3 Draft EIR Text Revisions

This chapter presents revisions to the Corte Madera Creek Flood Risk Management Project, Phase 1 (project) Draft EIR that was published on February 1, 2021. These revisions include both (1) changes made to text, tables, or figures in response to comments on the Draft EIR as discussed and presented in Chapters 2 and 3, as well as (2) staff-initiated text changes to correct minor inconsistencies, to add minor information or clarification related to the project, and to provide updated information where applicable. None of the revisions or corrections in this chapter substantially change the analysis and conclusions presented in the Draft EIR.

Figure 3.9-3 Floodway and Tsunami Inundation Zones

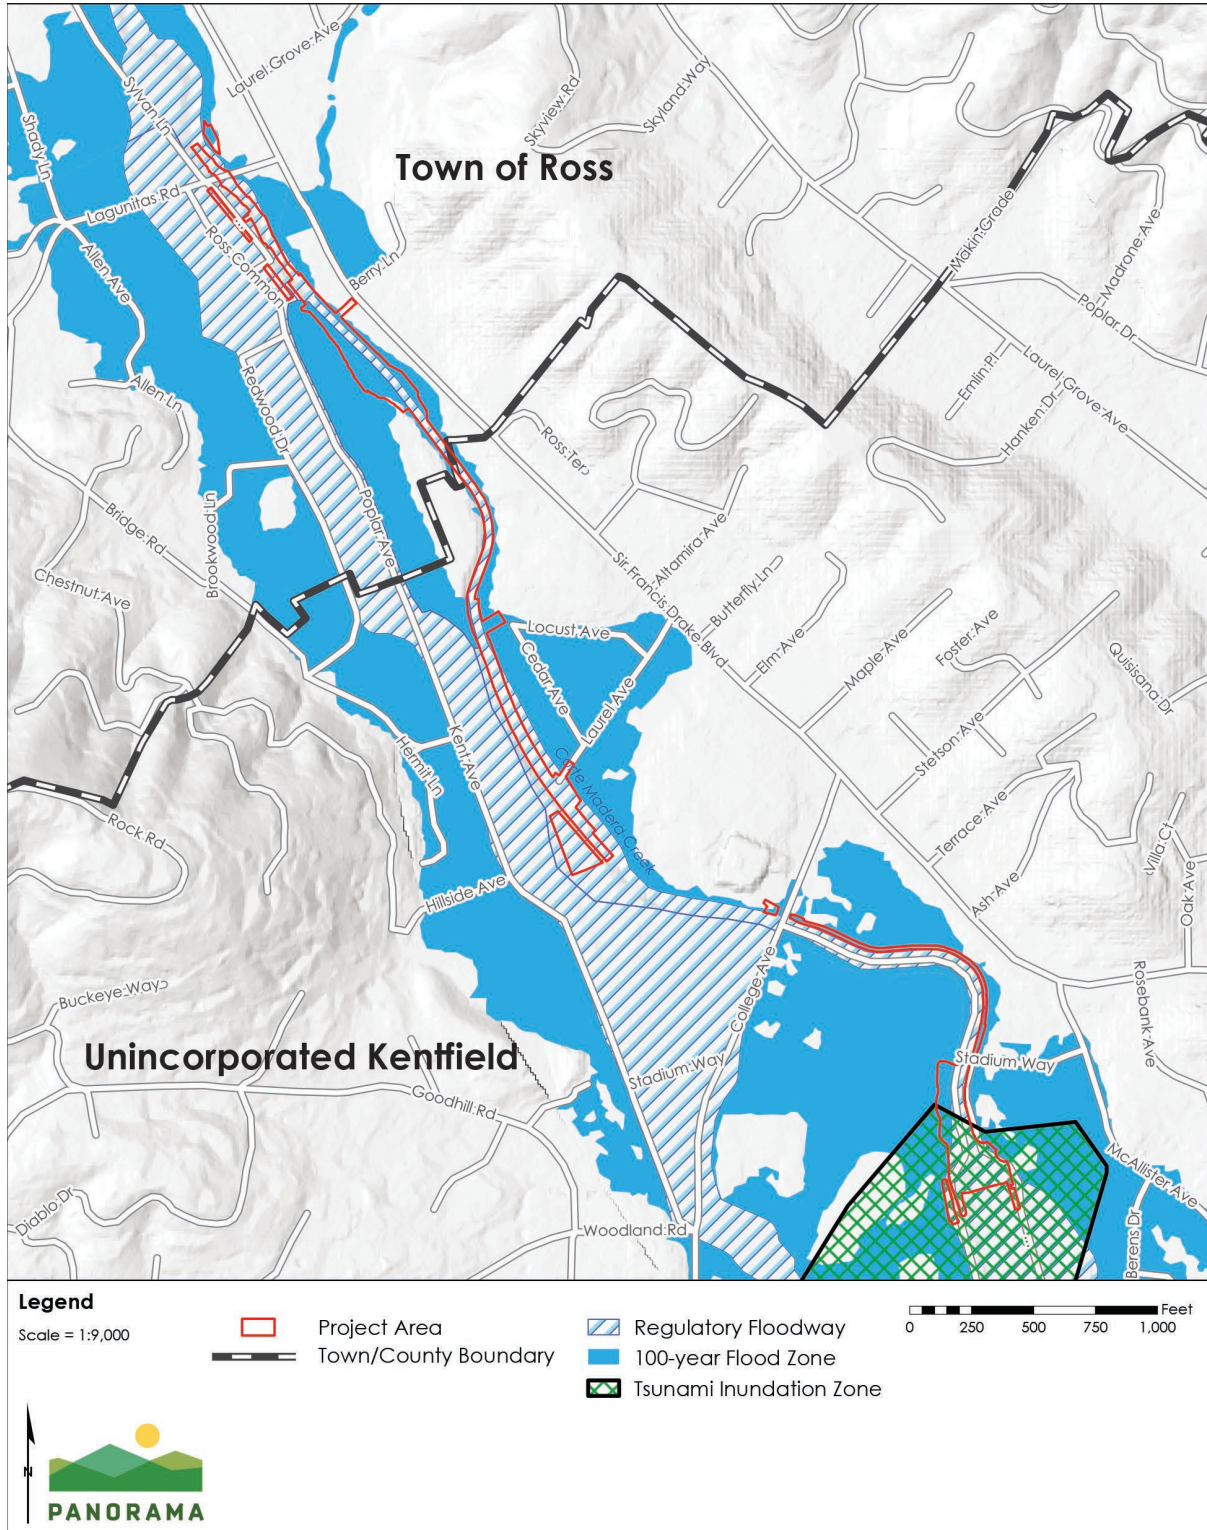
In response to comments B1-25 and B1-31, Figure 3.9-3 in the DIER (page 3.9-18) has been revised as follows:

Figure 3.10-3 Noise Measuring Sites and Sensitive Receptors within 1,000 Feet of the Project Area

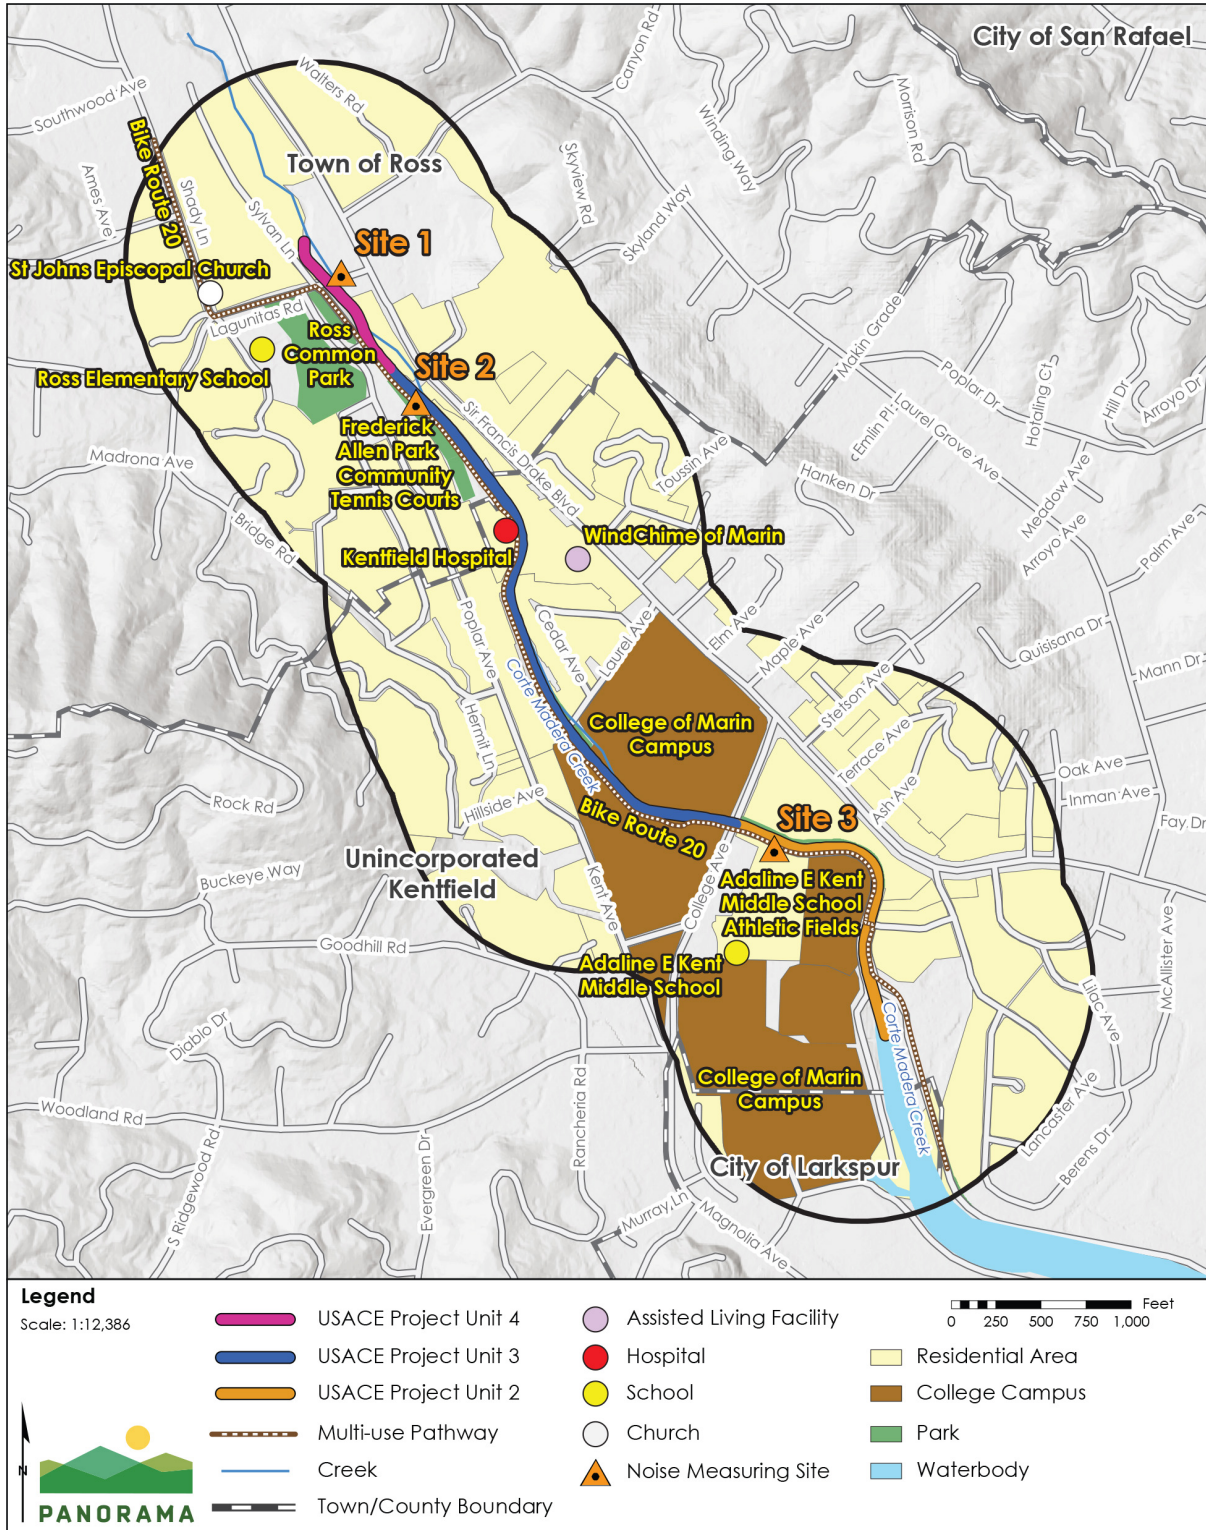
In response to comment B1-33, Figure 3.10-3 in the Draft EIR (page 3.10-10) has been revised as shown on the following page.

Figure 3.12-2 Parks and Recreational Facilities in the Project Area

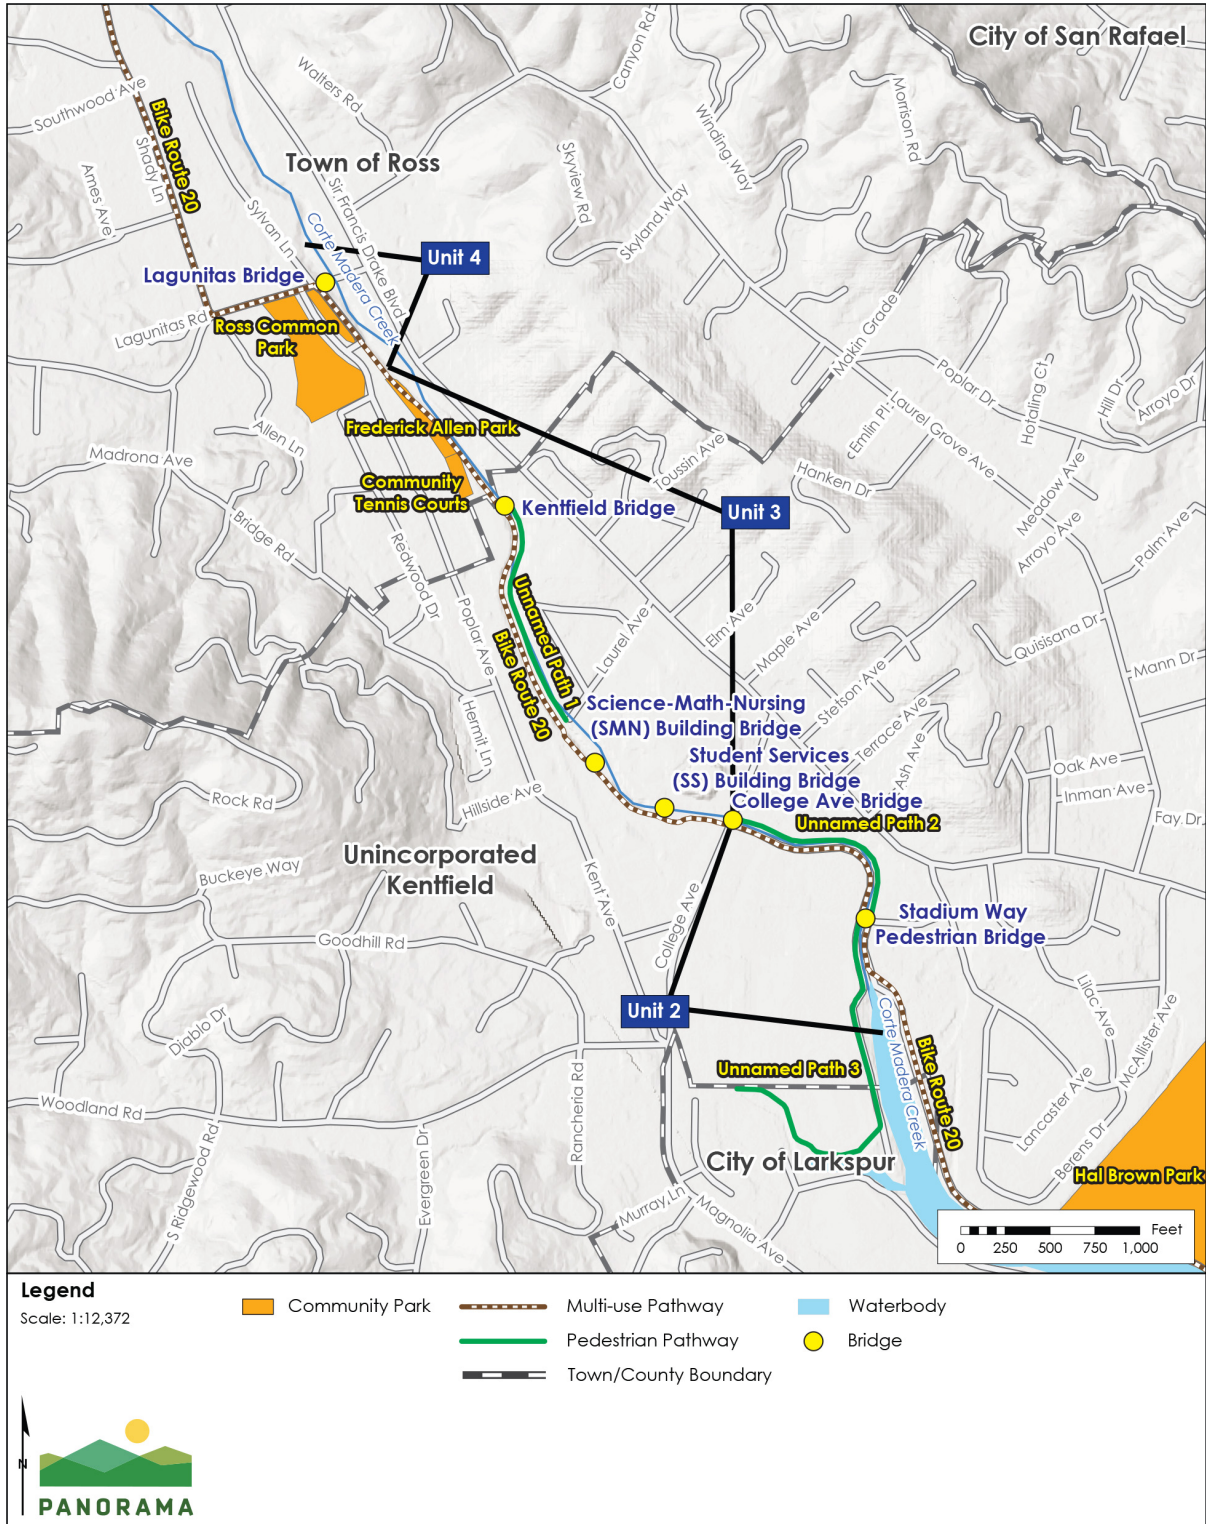
In response to comment B1-43, Figure 3.12-2 in the Draft EIR (page 3.12-4) has been revised, as shown on the following page.

Figure 3.13-1 Local Transportation Network

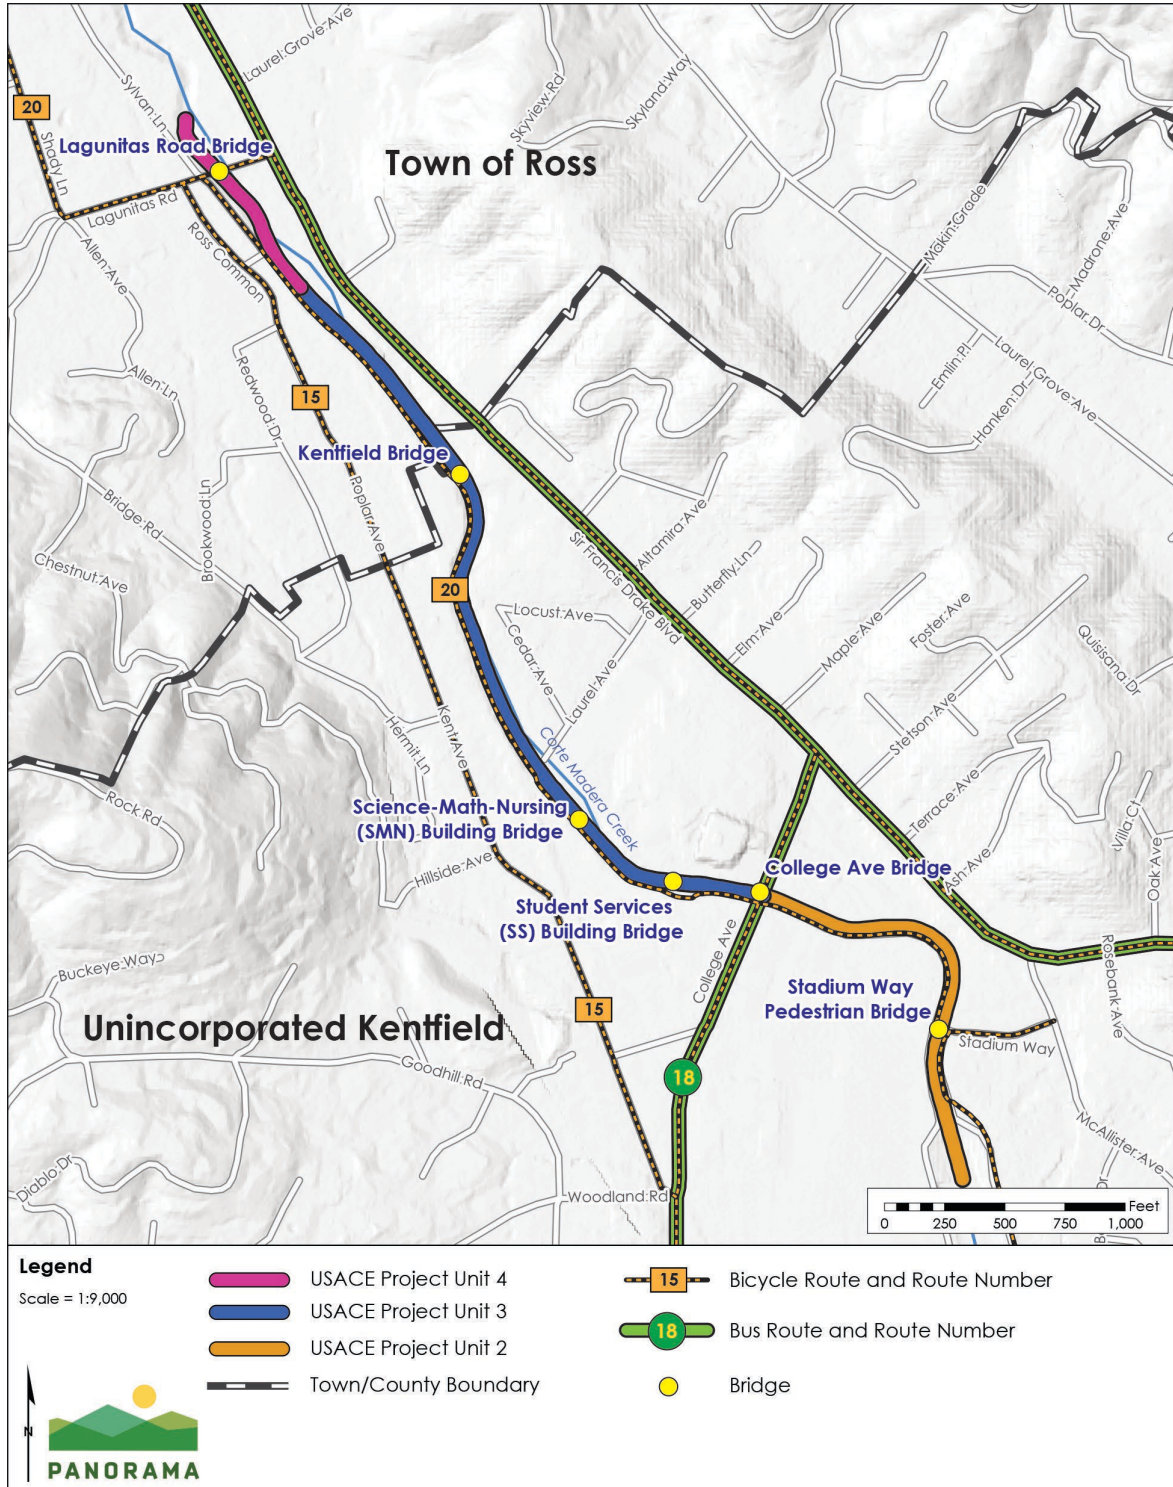
In response to comment B1-45, Figure 3.13-1 in the Draft EIR (page 3.13-3) has been revised as follows:

Figure 3.15-2 Utilities and Service Systems in the Project Area (Map 2 of 3)

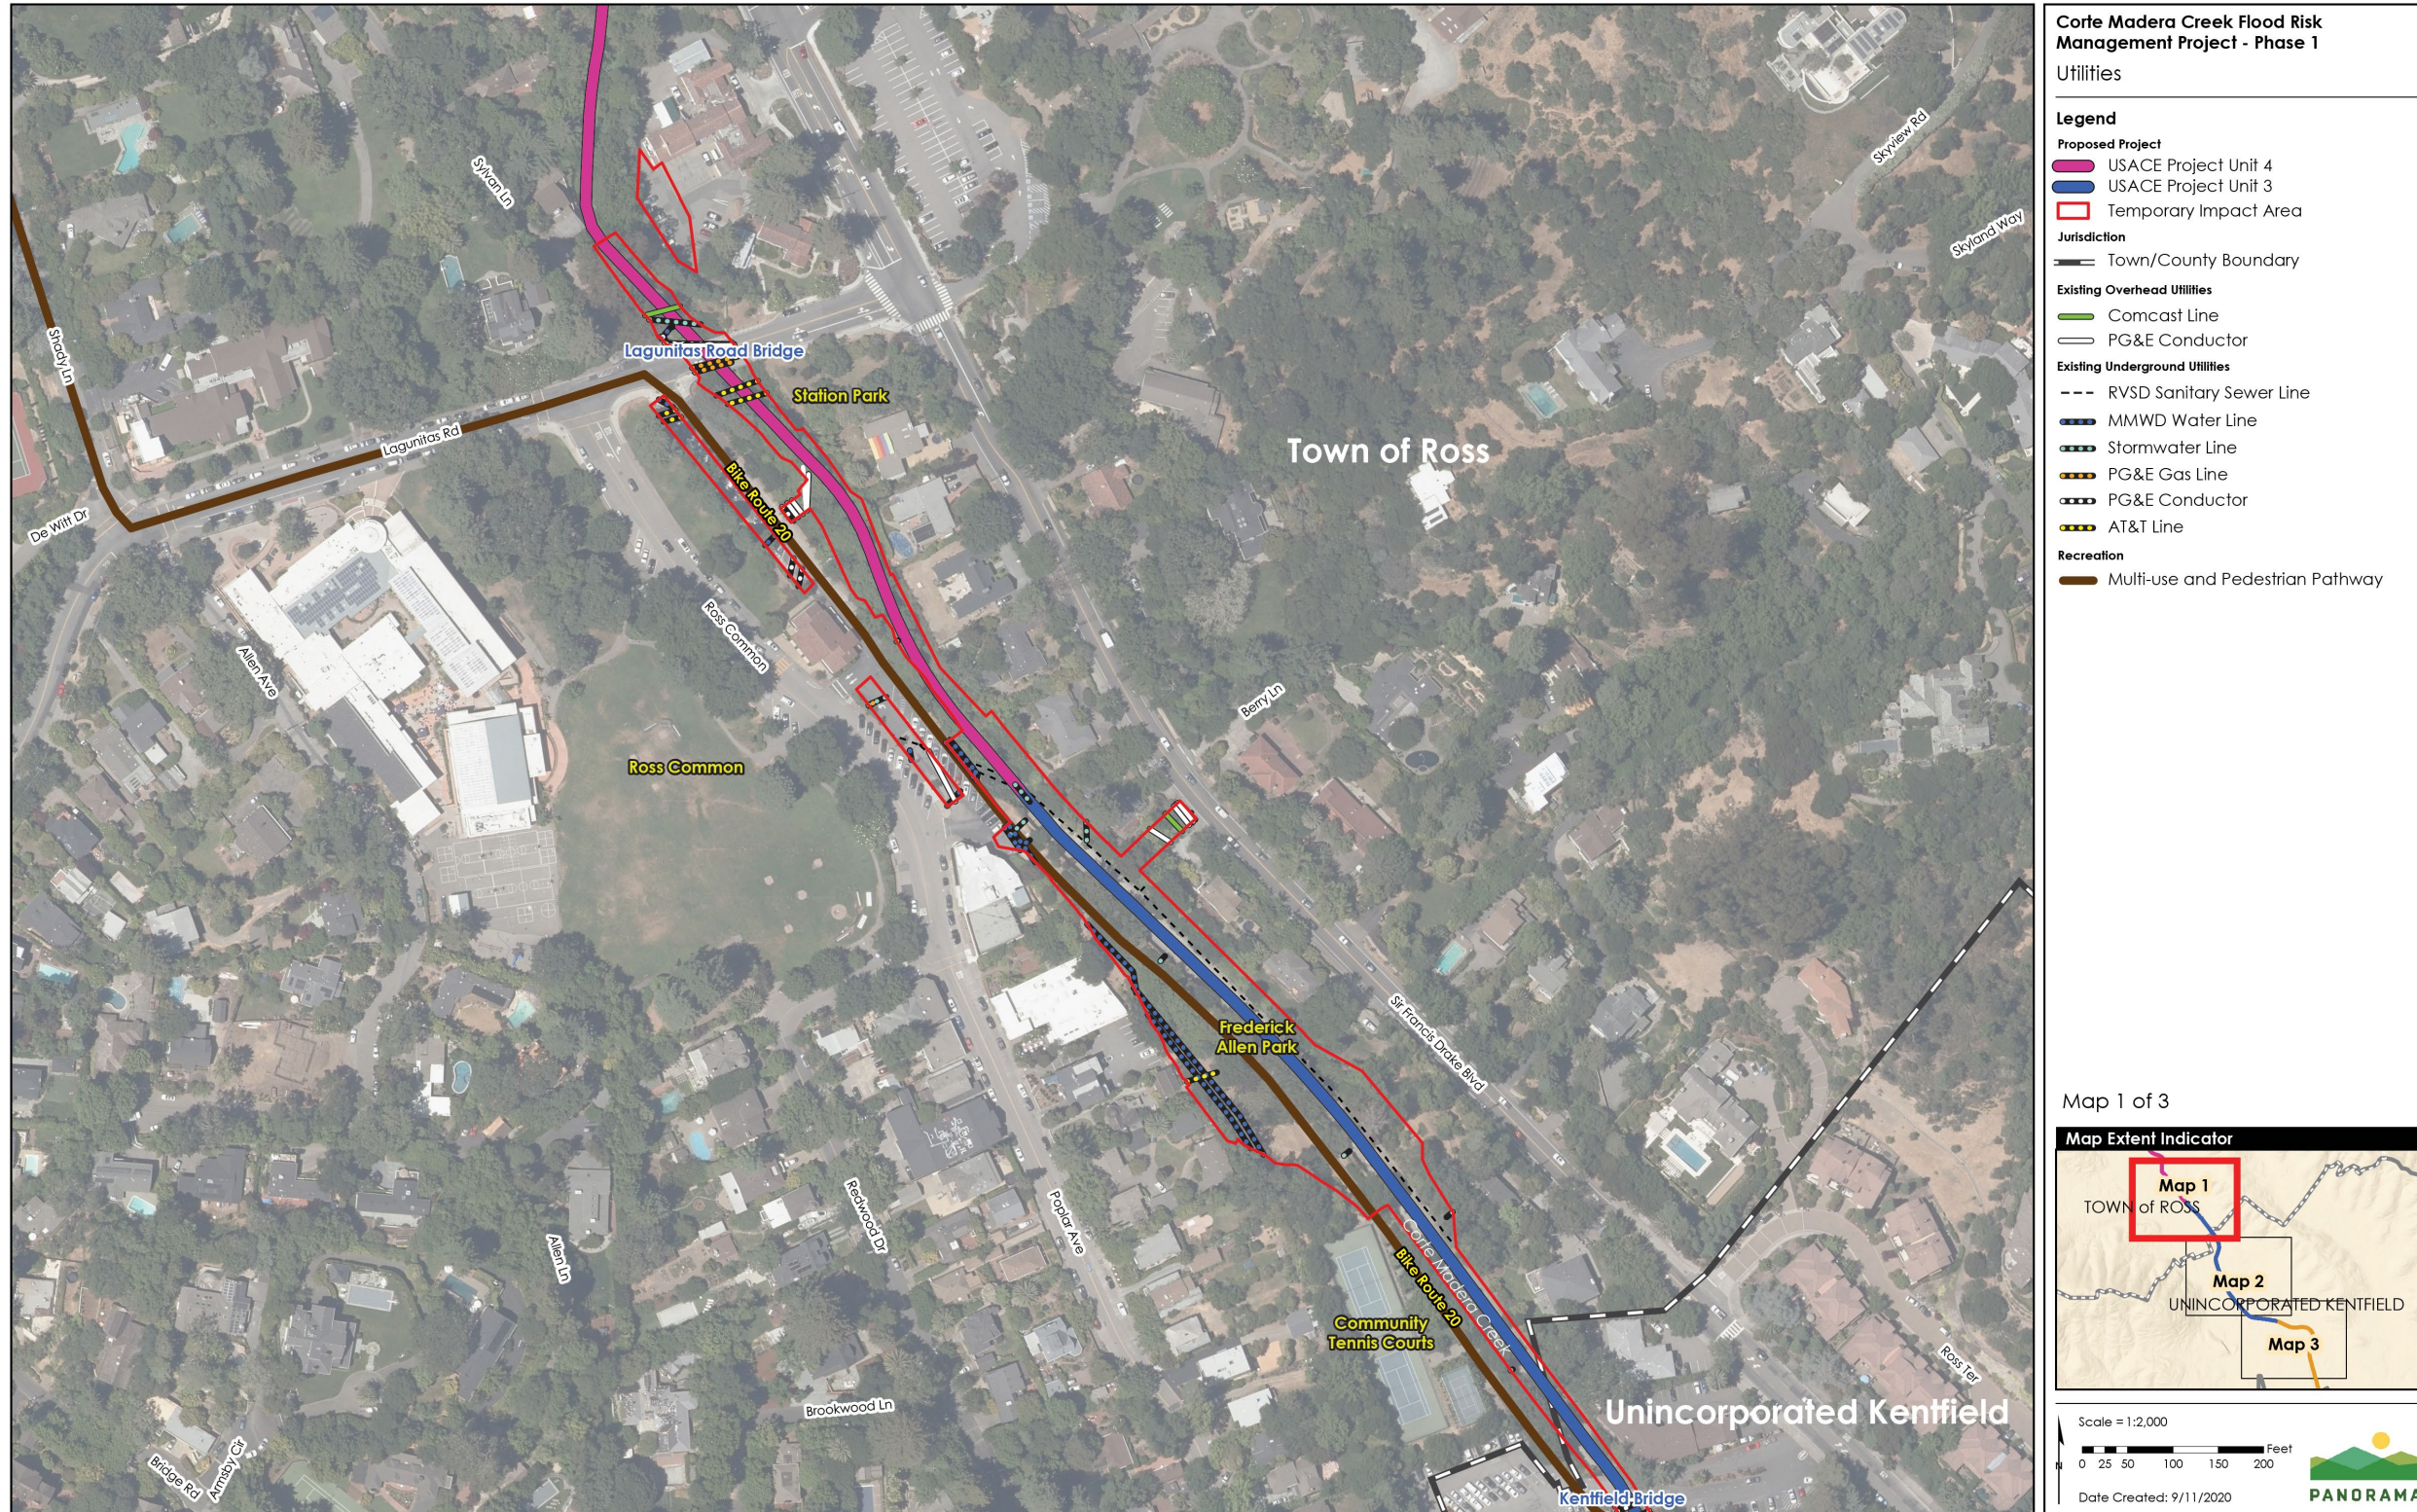
In response to comments B1-25 and B1-51, Figures 3.15-1, 3.15-2, and 3.15-3 in the Draft EIR (pages 3.15-3, 3.15-4, and 3.15-5) have been revised as follows:
